Tomar's Addition, Administrative Subdivision Plan No. 620200060

Request to create one lot from a parcel of land for a single-family detached house.

ADMINISTRATIVE SUBDIVISION PLAN
NO. 620200060

Figure 3: Final Warfield Street Cross-Section

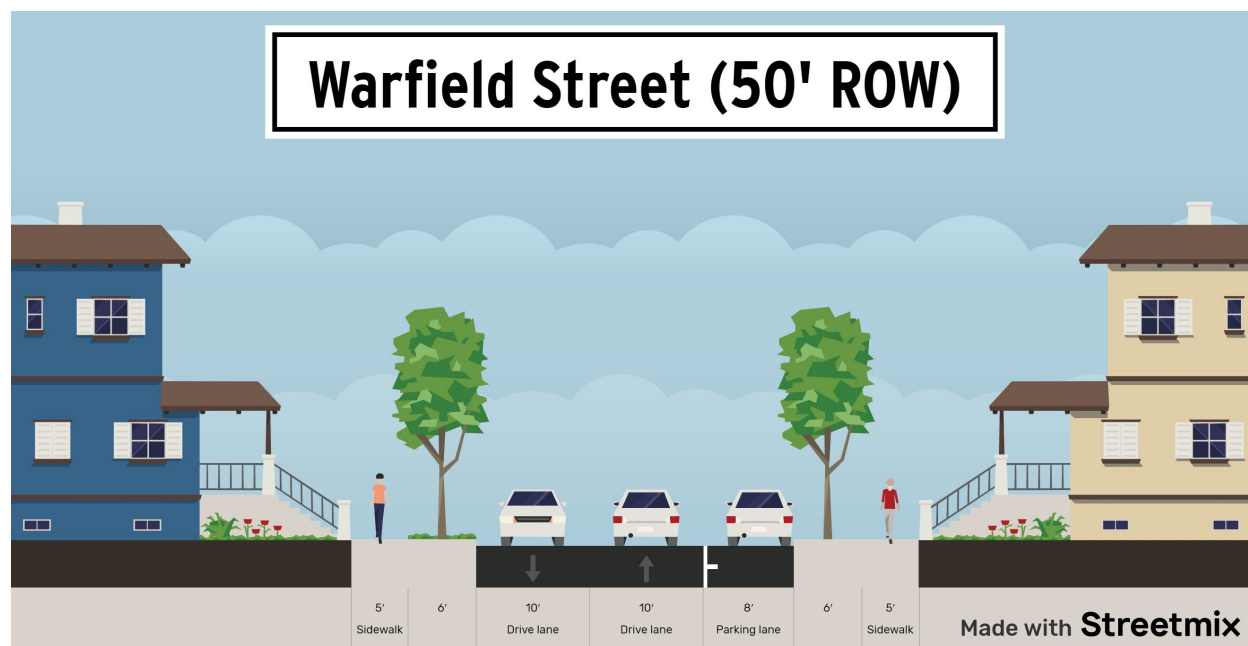
The proposed lot will have frontage and access from Warfield Street. Warfield Street was created through a 1914 record plat with a 40-foot right-of-way (ROW) and no additional dedication has occurred since the initial ROW creation. Warfield Street has approximately 16 feet of paving, with informal parking on both sides of the road. Montgomery County Department of Transportation (MCDOT) has agreed with Planning Staff that while this road would typically be classified as a Secondary Residential Street with a 60-foot ROW, this road can be accepted as a Secondary Residential Street with a 50-foot ROW. However, any ROW dedication would reduce the lot size below the minimum necessary for development. Thus, the Applicant is requesting to provide a 5-foot Public Improvement Easement (PIE) in lieu of dedication, with frontage improvements including a 5-foot sidewalk and 6-foot tree panel, as shown on the Administrative Subdivision Plan. This is an interim condition, with the final cross-section shown in Figure 3. As outlined in the findings below, MCDOT and Planning Staff support this request, as it allows for an acceptable cross-section, while providing safe and acceptable pedestrian and vehicular circulation.

2. Show on the certified preliminary plan the following roadway cross section for Warfield Street that accommodates the existing right-of-way and PIE (from the centerline of the street):
 - a. 10-foot travel lane
 - b. 8-foot parking lane
 - c. 6-foot tree panel
 - d. 5-foot sidewalk
3. The driveway shall have a minimum of 25 feet in length between the garage door and the property line.
4. **Sight Distance:** A Copy of the accepted Sight Distance Evaluation certification is enclosed for your information and reference.

WATER CLASS	I-P	WATERSHED	LOWER ROCK	FEMA FLOODPLAIN MAP PANEL #	24031C03650
TRIBUTARY	NULL				
TAX MAP	HP343	200' SHEET	213NW04	ADC MAP PAGE	36 C-3
SCALE	AS SHOWN	DATE	FEB. 2020	PROJ. NO.	19-010
				SHEET NO.	L-1.1

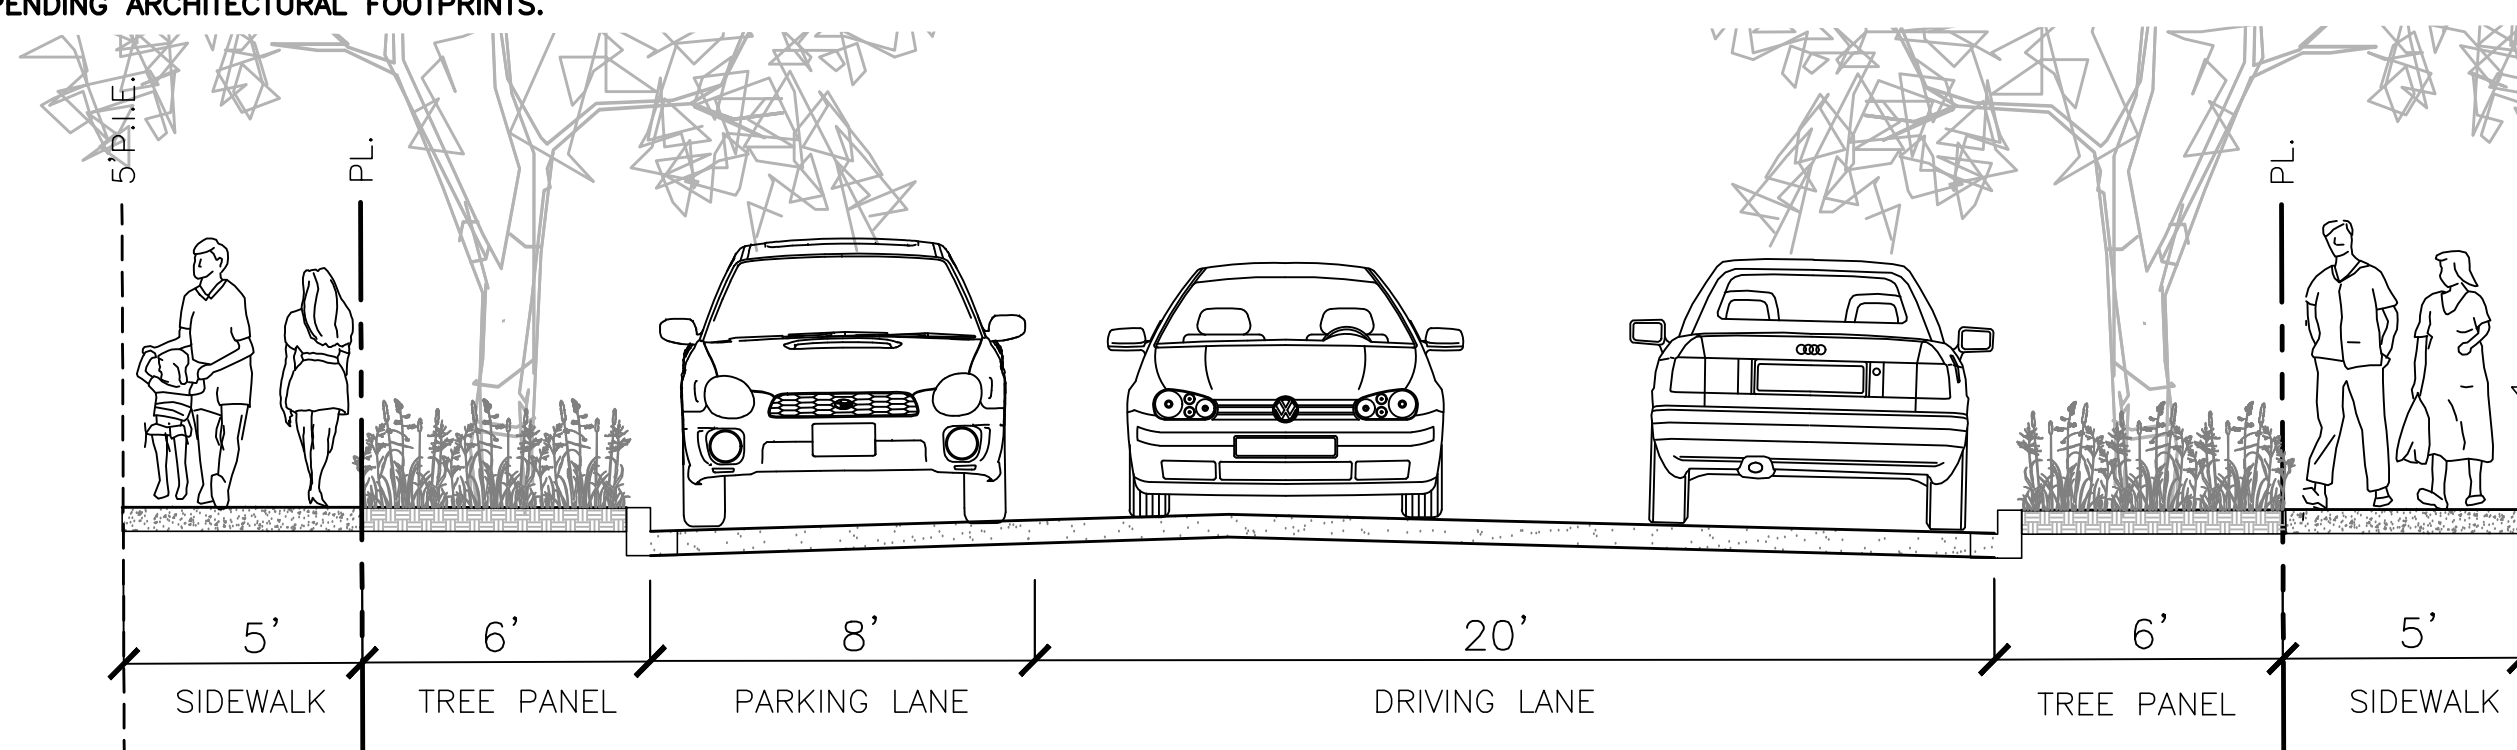
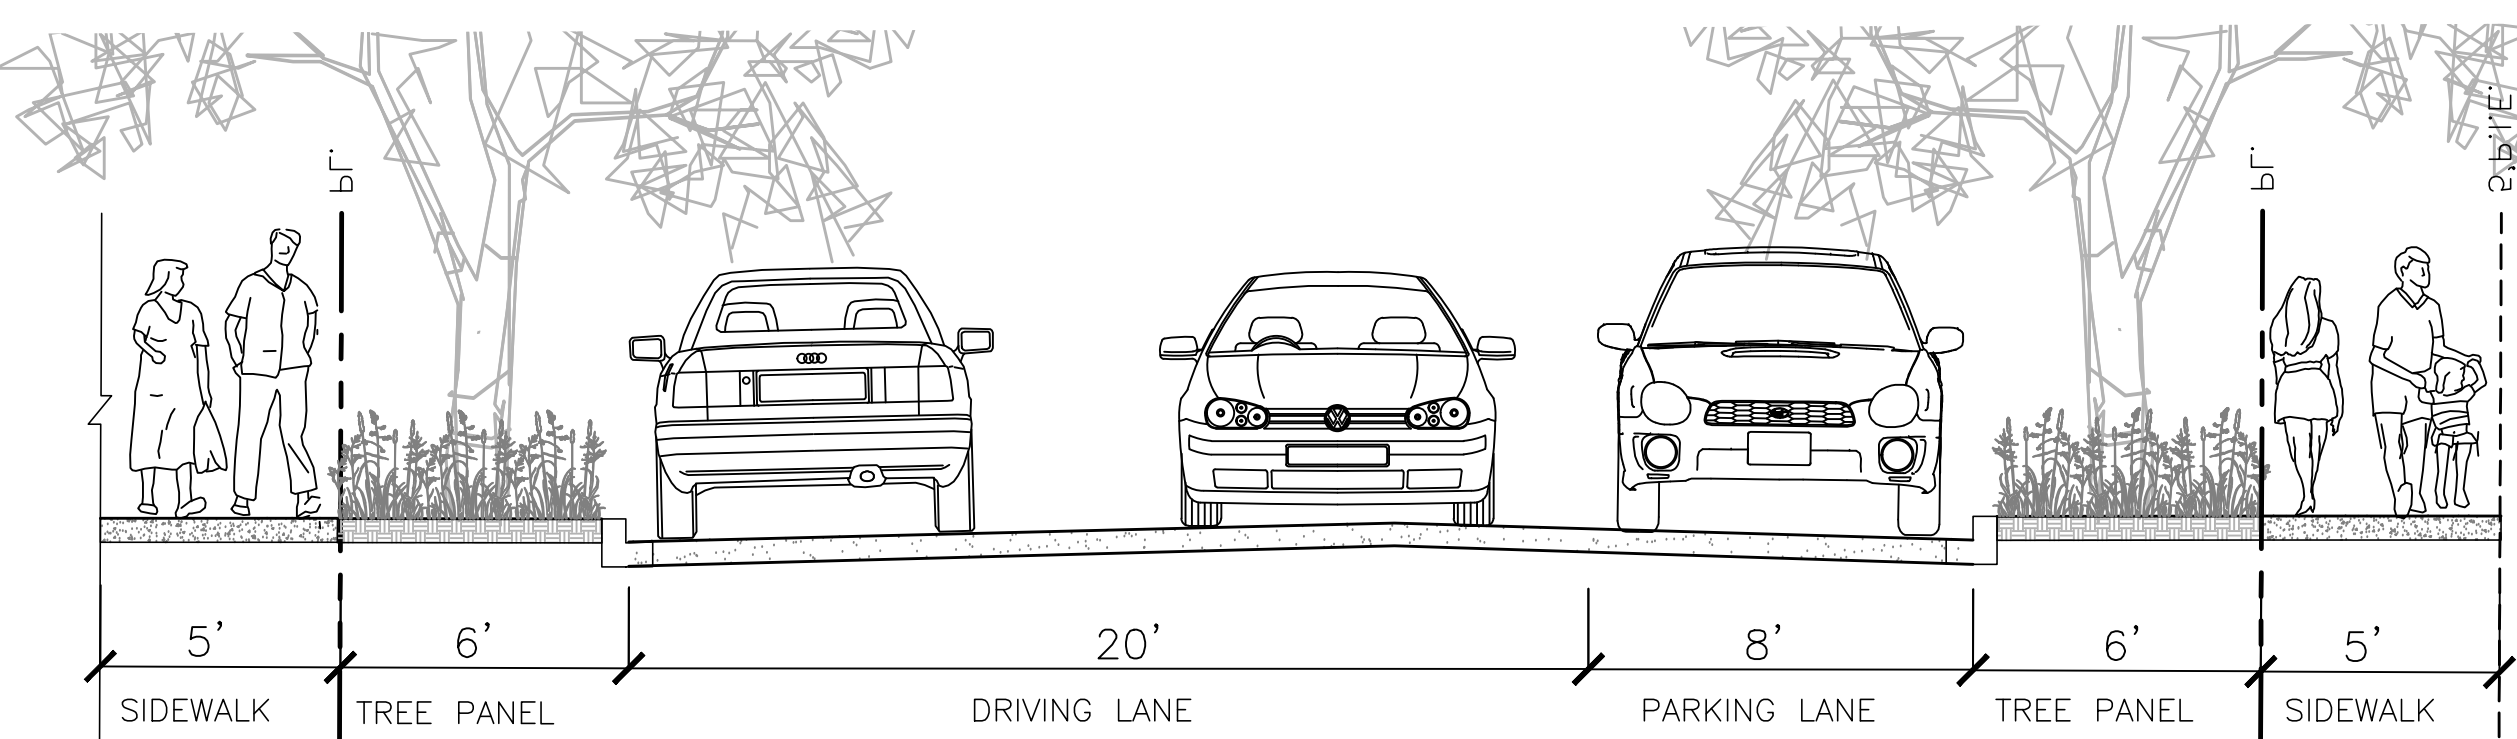
12. The certified Preliminary Plan must show the following changes:
 - a. Remove Standard No. MC-2002.02 from sheet L-1.1.
13. The Applicant must include the stormwater management concept approval letter and Preliminary Plan Resolution on the approval or cover sheet(s).
14. The certified Preliminary Plan must contain the following note:
